**POTENTIAL IMPACTS OF GOLD MINING IN THE RAGGED TOP
AREA ON SPEARFISH CANYON, SOUTH DAKOTA**

**Prepared for
Spearfish Canyon Owners Association**

Nuri Uzunlar, PhD

August 28, 2020

Figure 10. Topographic map of the area showing groundwater monitoring wells and proposed mining pit (from VMC permit application)

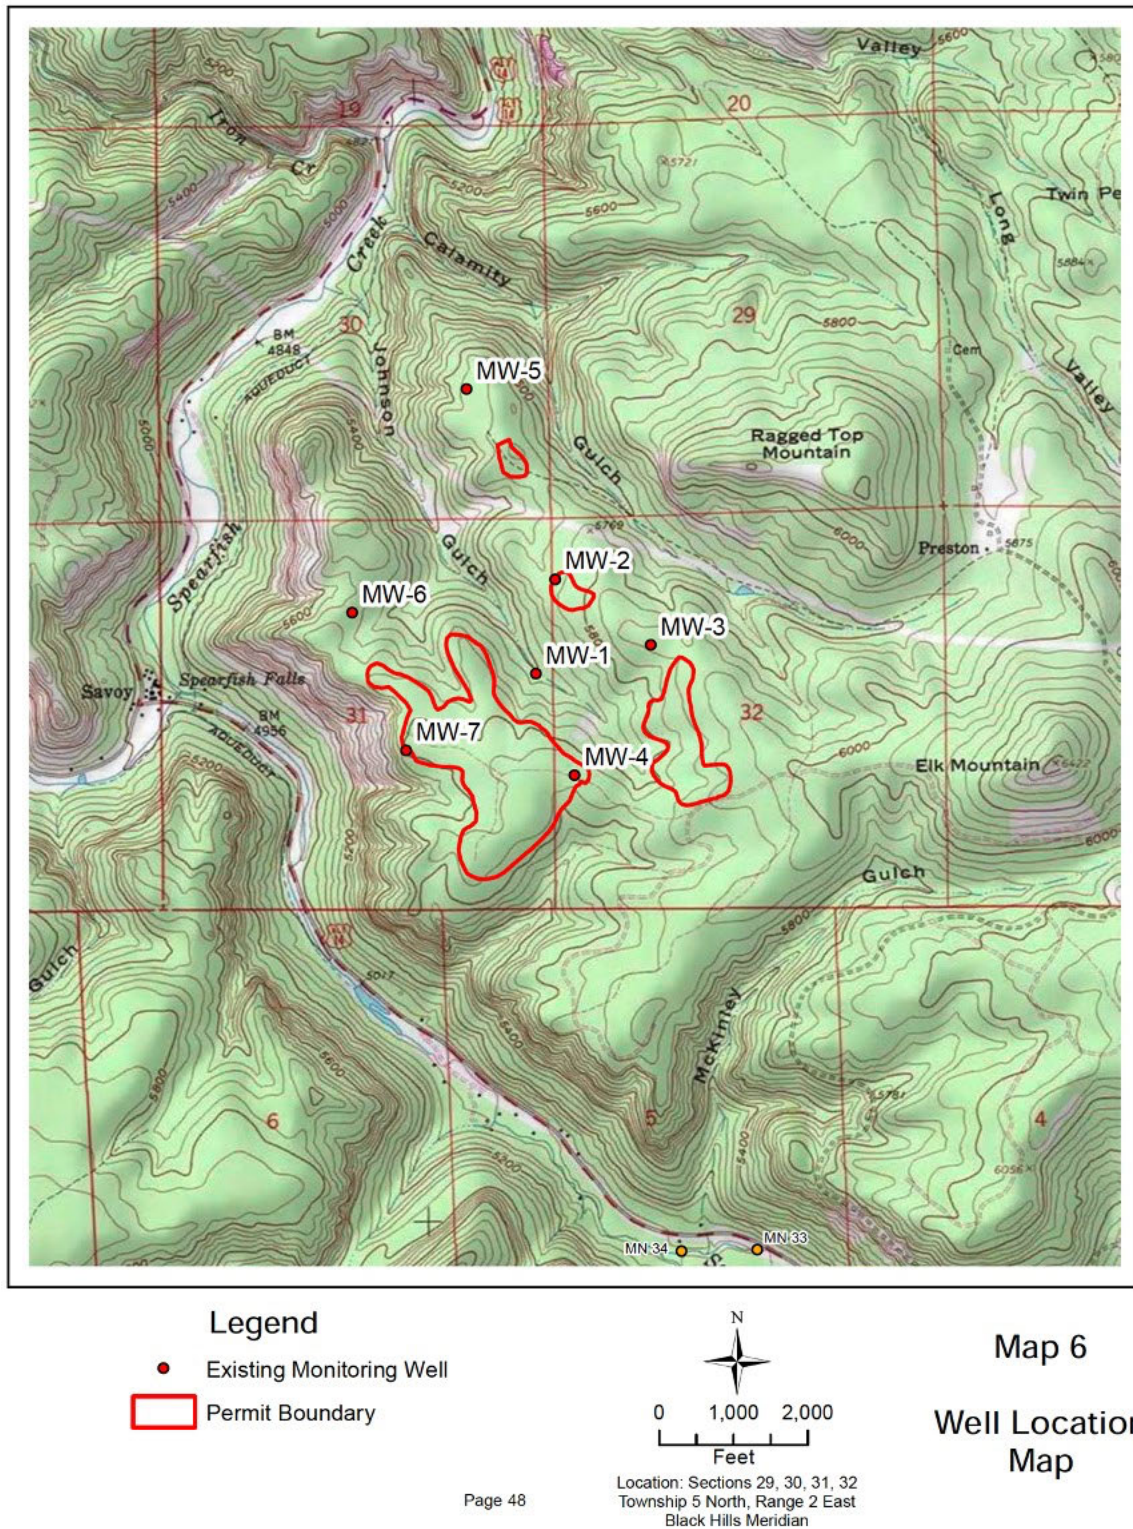
VMC LLC maintains a network of surface water and groundwater quality monitoring stations associated with the project and has collected baseline water quality data for surface water and groundwater. Seven groundwater monitoring wells are present in the vicinity of the project area (Figure 10).

Based on data collected from monitoring wells within the permit area, the water table is about 450-500 feet below the surface (company officials oral communications, August 2020).

Therefore, Pahasapa Limestone is not considered an aquifer in the Ragged Top district.

Figure 12. Diagrammatic sketch showing potential ore horizons (in black) within Paleozoic formations below Pahasapa Limestone in Ragged Top mining district. Modified from Uzunlar, 1993.

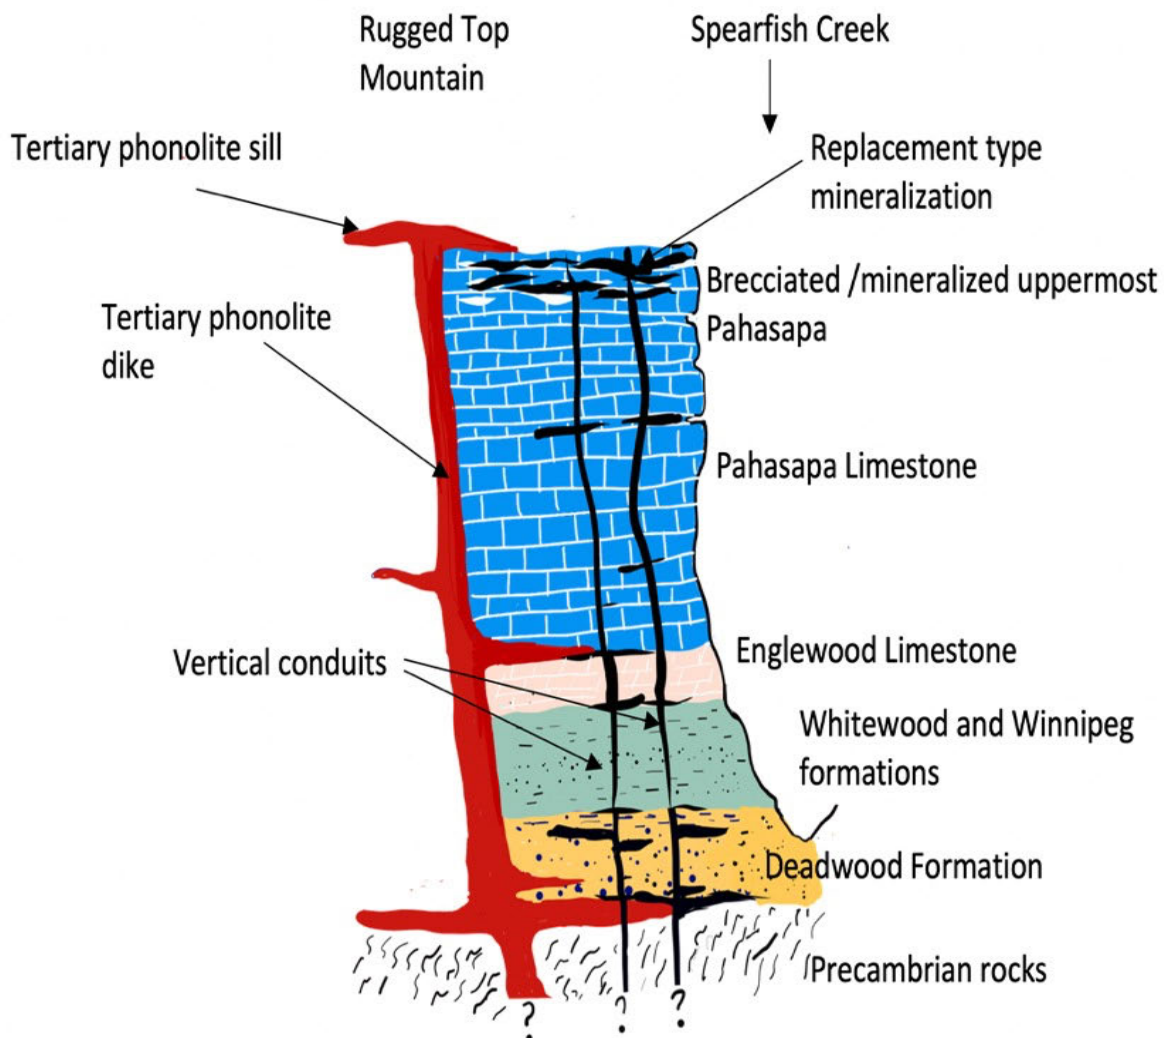
Expansion of project - Going deeper: As illustrated in figure 5 (also posted here as Figure 12 for easier following) the area potentially contains more than one level of mineralization. Although formations below Pahasapa limestone are not mineralized in Spearfish canyon they could contain economic mineralization (ore) in the lower formation below Pahasapa Limestone, as it was and is in the mines operated by Wharf less than a mile south of Ragged Top, Deadwood Formation may be too deep to be economically mined even with current gold prices above \$2000/oz. However, if there is low grade but continuous mineralization below the current permit area, then the mining operation could easily reach to multi-million tons ore removal from the area. If gold prices keep above \$2000/oz or even go higher passing \$2500 per ounce in the coming years, the company could decide to apply for permit to build a mill and cyanide processing on site. A scenario like this would certainly be a tremendous threat to Spearfish Canyon. The ore processing and cyanide leaching aspects of the mining operation are not

Figure 14. Map showing historic mining districts and future mining potential (gray area) in Spearfish Canyon (Modified from DeWitt et al, 1986).

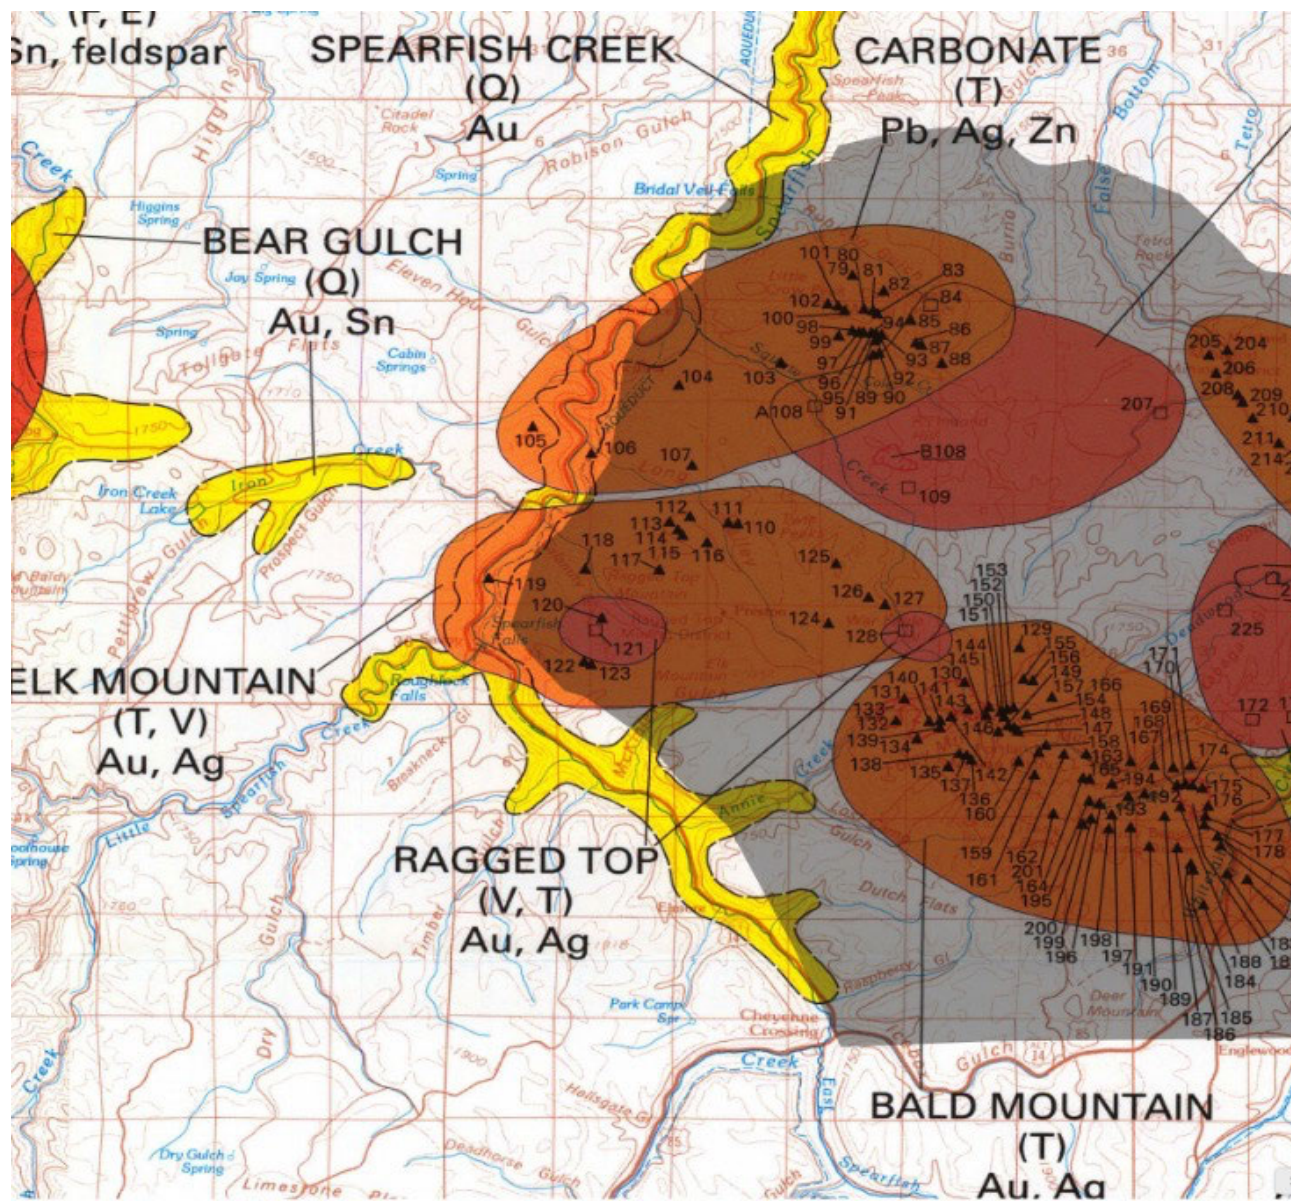
Based on my extensive knowledge of these deposits and historical data; the entire area, as outlined in Figure 11 (grey shaded) east of Spearfish Canyon from Cheyenne Crossing to Bridal Veil Falls would be mineable at profit with gold prices above \$2000 per ounce.

Under the current mining climate, increasing gold prices, and effective mining methods, a large mining company could consolidate these districts and initiate a large-scale gold mining operation in Ragged Top and Carbonate mining districts. Mining operation at this scale would bring up number of issues including, air and water quality, acid mine drainage, cyanide contamination, run offs, spills and many more. This could have irrecoverable negative effects on Spearfish Canyon.

Figure 15. Proposed permit area (Figure modified from VMC permit application), showing vantage points and currently operation Wharf mine. The yellow box is about 100 acres. Total disturbed area including roads and prep sites could easily exceed 200 acres.

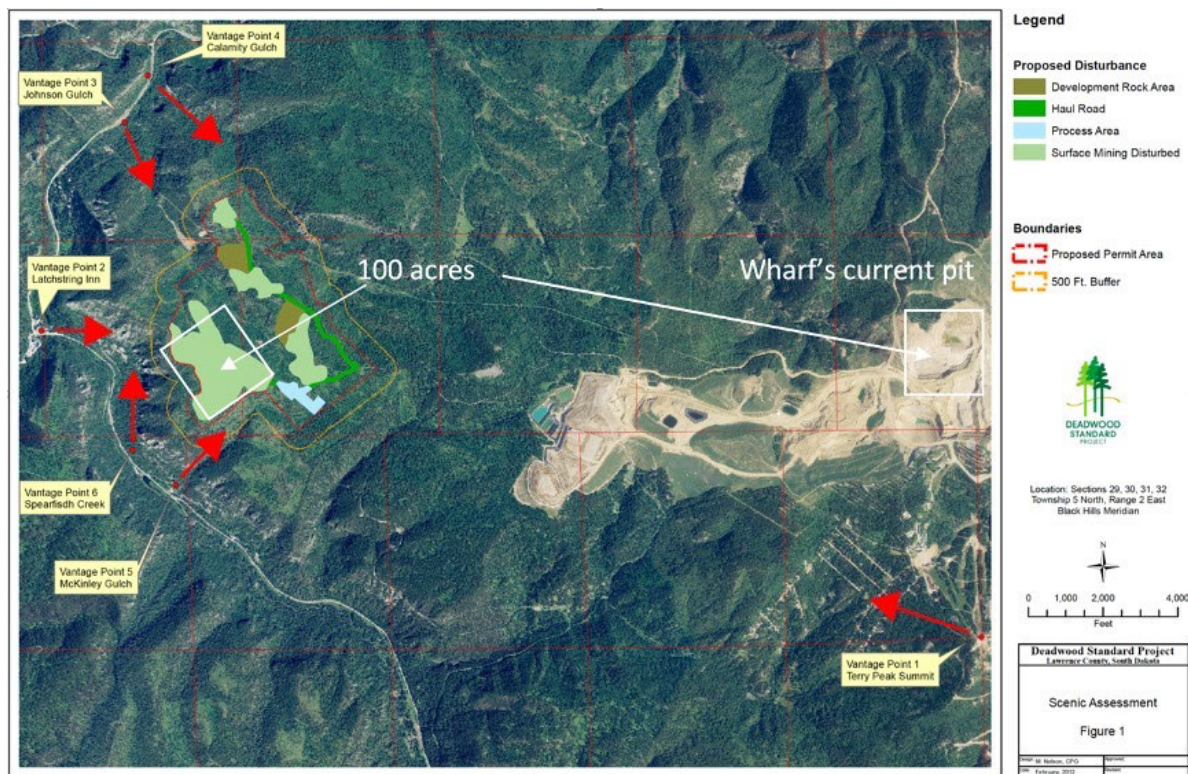
The original Homestake Mining Company Permit 416 proposes mining ore in more than 120 acres. Valentine Mining Company submitted a modified version of the permit 416 in 2012 proposing mining in a total area more than 170 acres. This translates to 200 plus acres of disturbance considering 20% buffer zone around the proposed pit limits. Figures 12 and 13 show the area of interest, including the buffer zone, is clearly bigger than 500 acres. Request to see mine plans and related ore deposit model was declined by company officials, therefore we have to make some calculated assumptions. Assuming total disturbed area is 200 acres as pointed out in the caption of figure 12.

1 acre = 4046 m², 200 acres = 809,200 m²

If top 10 meters is mined that would be roughly 8 million m³– density of limestone is around 2.5 gr/cm³ (2.5 ton/m³) which brings total rock removal roughly to 20 million tons. If top 20 meters is mined total rock removal would be 40 million tons. Part of the mineralized zones are as deep as 70+ feet in which case total mined/disturbed rock would be greater than 40 million tons. Even if total disturbed are is limited to 100 acres with a total of 20 meters of mining depth total amount of rock disturbance would be about 20 million tons at minimum. It is stated in the application that the overburden is about 10 meters thick in some areas but is not specified where and how many acres. Overburden removal alone could be as much as 10 million tons. VMC claiming to extract 70,000 oz of gold from 870,000 tons of ore. To obtain such numbers the average ore grade needs to be 0.8 oz/ ton or greater. Company officials would not elaborate on geologic or mine model with reflecting ore grade calculated based on 900 exploratory drill holes. Based on the historic data it can be said with confident that the average bulk grade within the proposed area is around 0.03-0.05 oz/ton.
